May 20, 2022

RE: Final Revisions to Mineral License Application

**Aggregate Industries**  
Sharon Township, Washtenaw County, MI  
Mineral Extraction

**C201**

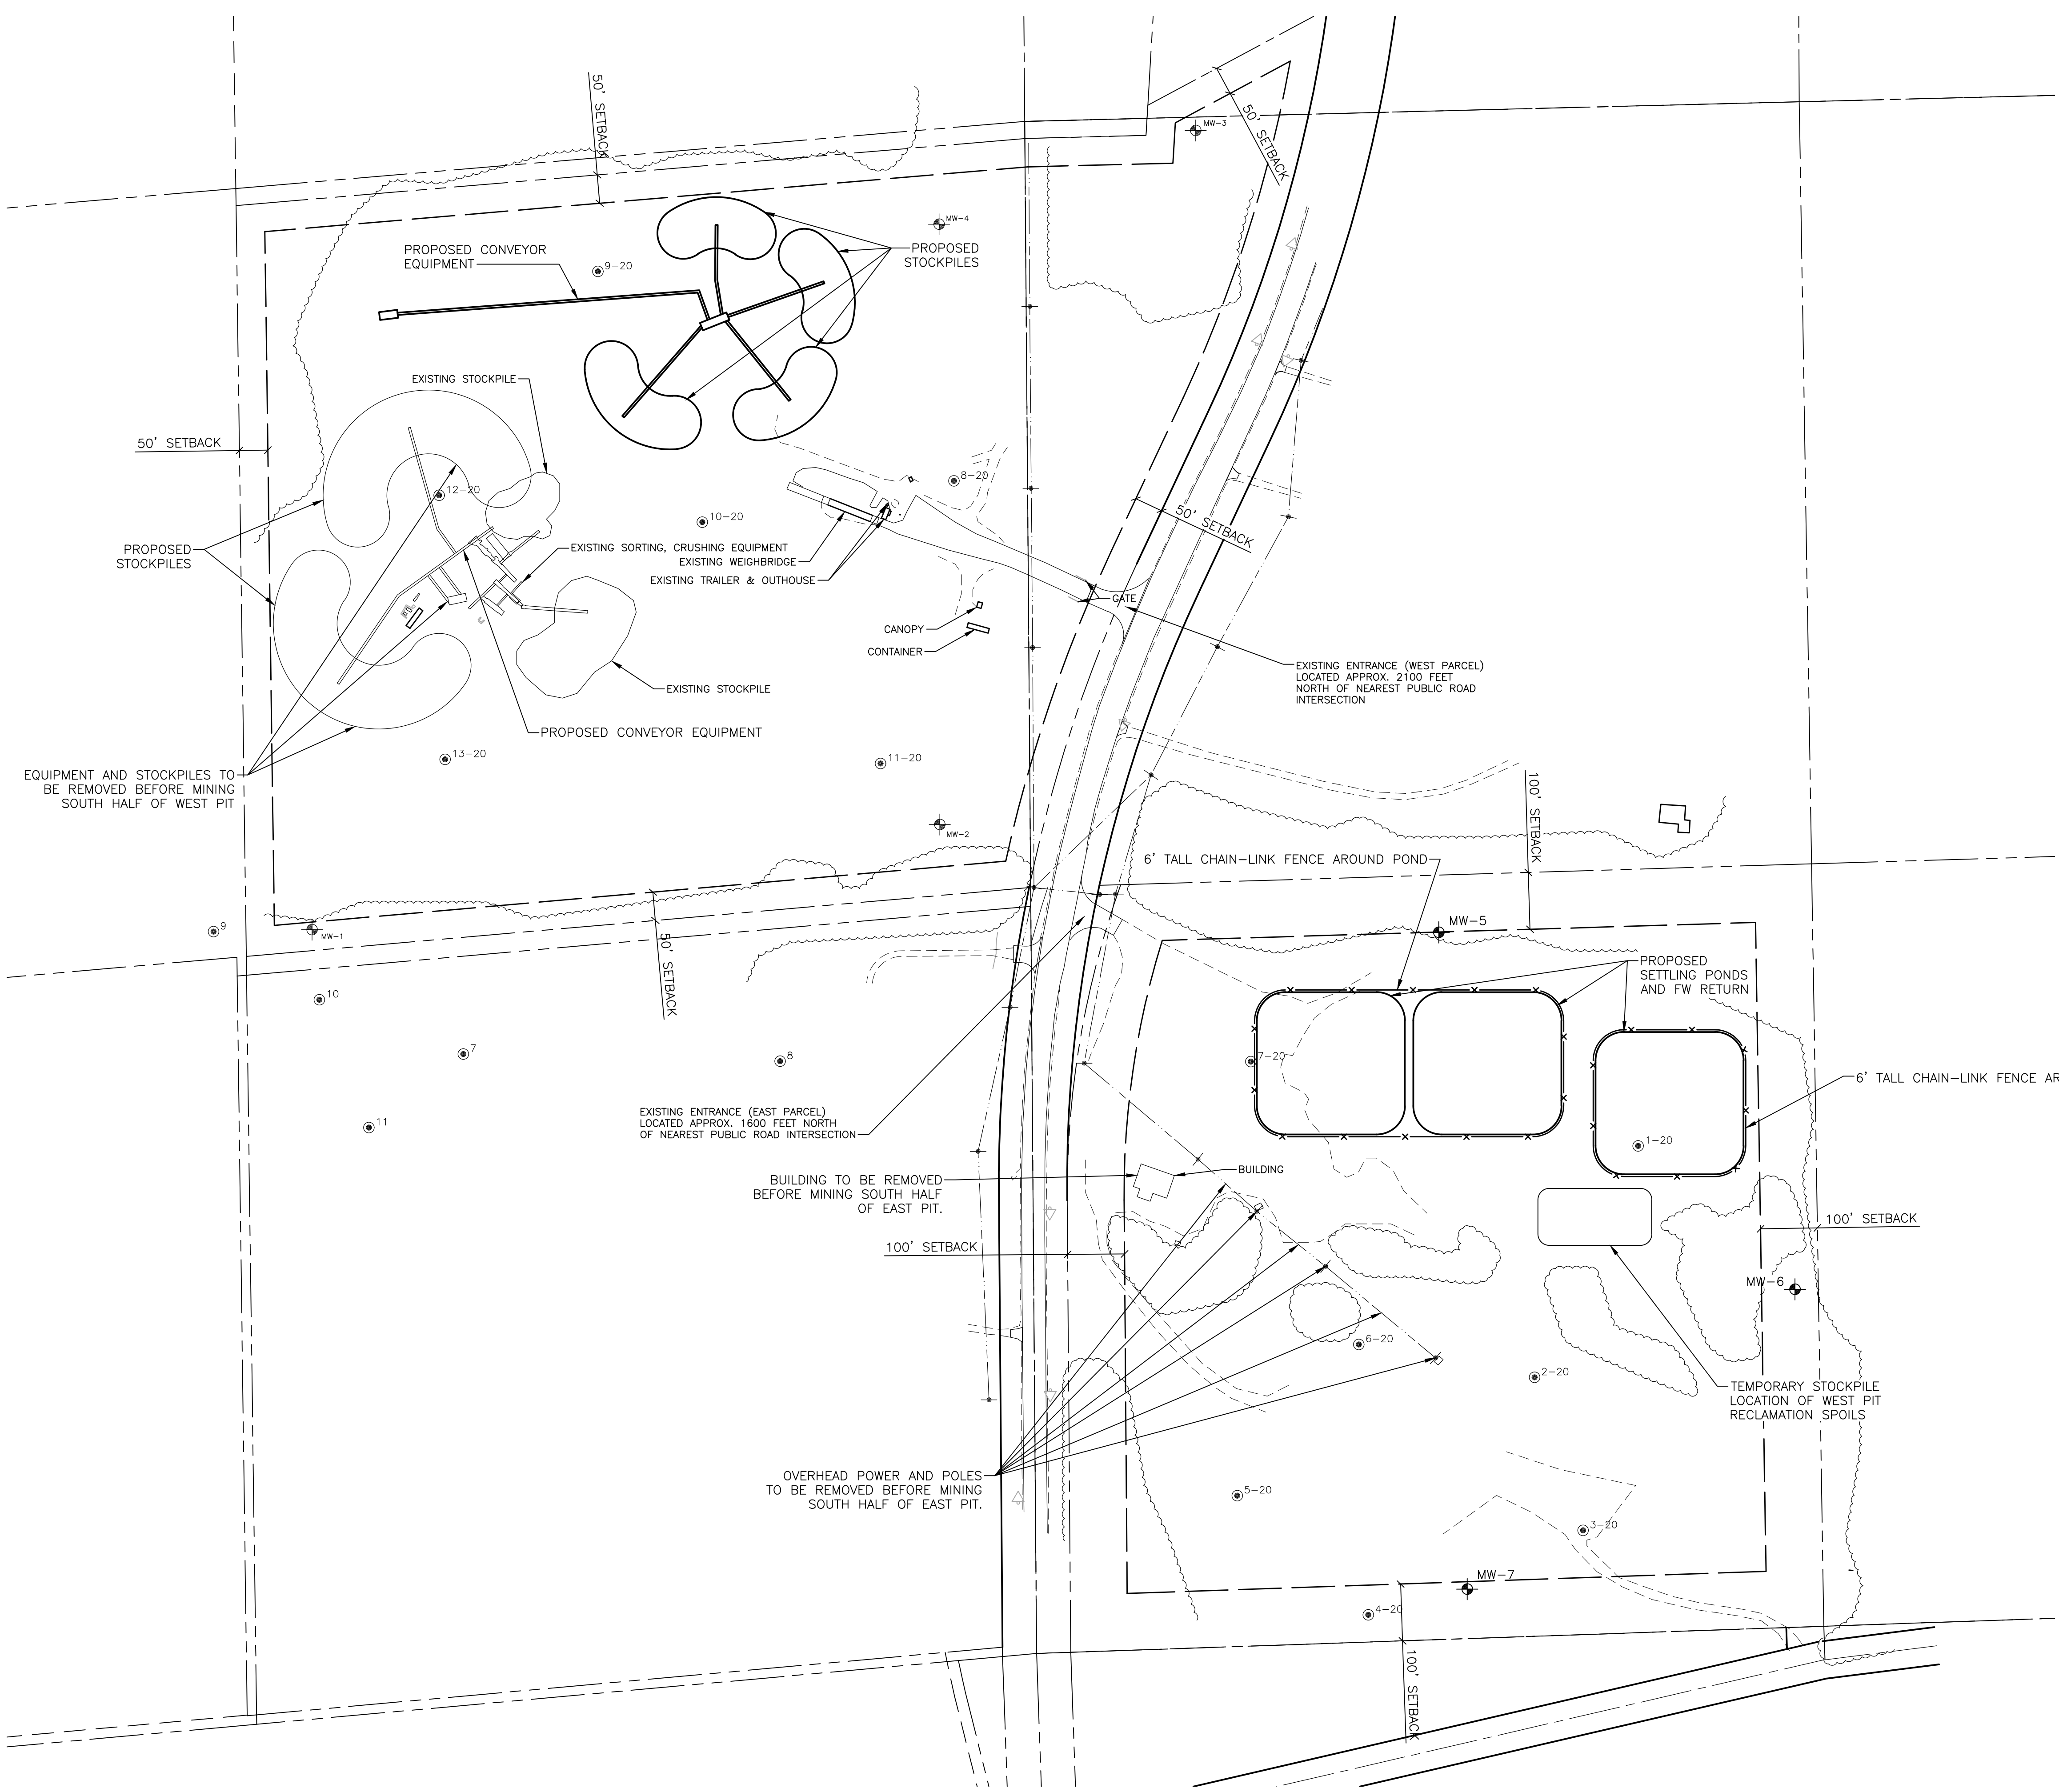
- Attachment 2:
  - Plan Sheet C201: Revised to show temporary soil storage area per Spicer's May 13, 2022 reclamation cost estimate review letter.
  - Plan Sheet C301: Updated to show the approved water line crossing design beneath M-52 per MDOT's right-of-way permit.
